Product Change Notification

Change Notification #: 118822-00
Change Title: Select Intel® NUC Rugged Chassis Element CMCR1ABC and Intel® NUC Rugged Board Element CMB1ABC, PCN 118822-00, Product Design, Product Material, Label, Firmware, Label and Box Updates
Date of Publication: January 07, 2022

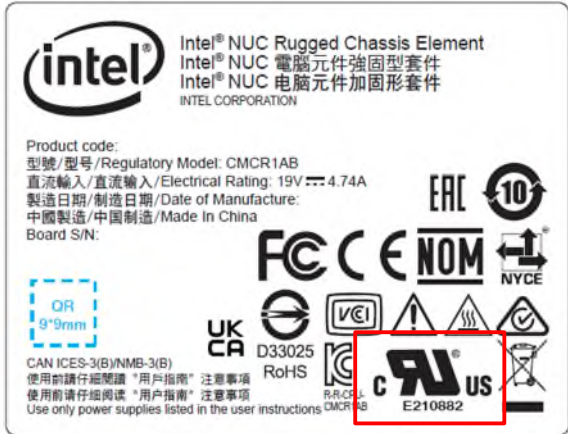
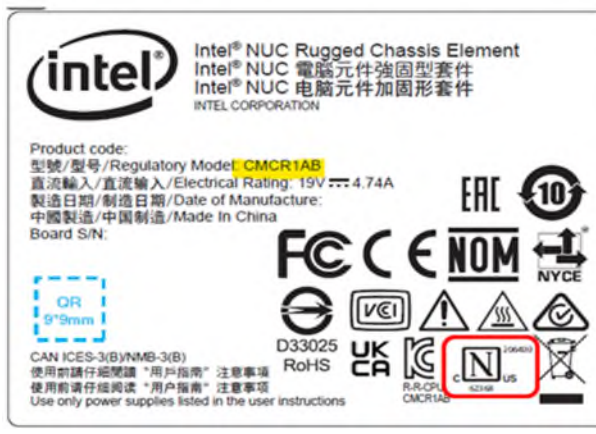
1. Change CB logo on rating label from UL to NTRL due to Lab convert from UL CB to Nemko NRTL CB
2. Added Taiwan battery recycling mark on box label.
3. Update Embedded Firmware version to 2.23
4. Update HDMI Firmware version to 5.06.001

Change from old part	Change to new part
<p>Rating label with NTRL logo</p> <p>Before:</p>  <p>The image shows a rating label for Intel NUC Rugged Chassis Element CMCR1AB. It features the Intel logo, product code, and various regulatory marks including ENEC, FCC, CE, NOM, UKCA, VCCI, and UL. The UL logo is highlighted with a red box. The label also includes text in multiple languages and a QR code.</p>	<p>After:</p>  <p>The image shows the updated rating label for Intel NUC Rugged Chassis Element CMCR1AB. It features the Intel logo, product code, and various regulatory marks including ENEC, FCC, CE, NOM, UKCA, VCCI, and NTRL. The NTRL logo is highlighted with a red box. The label also includes text in multiple languages and a QR code.</p>
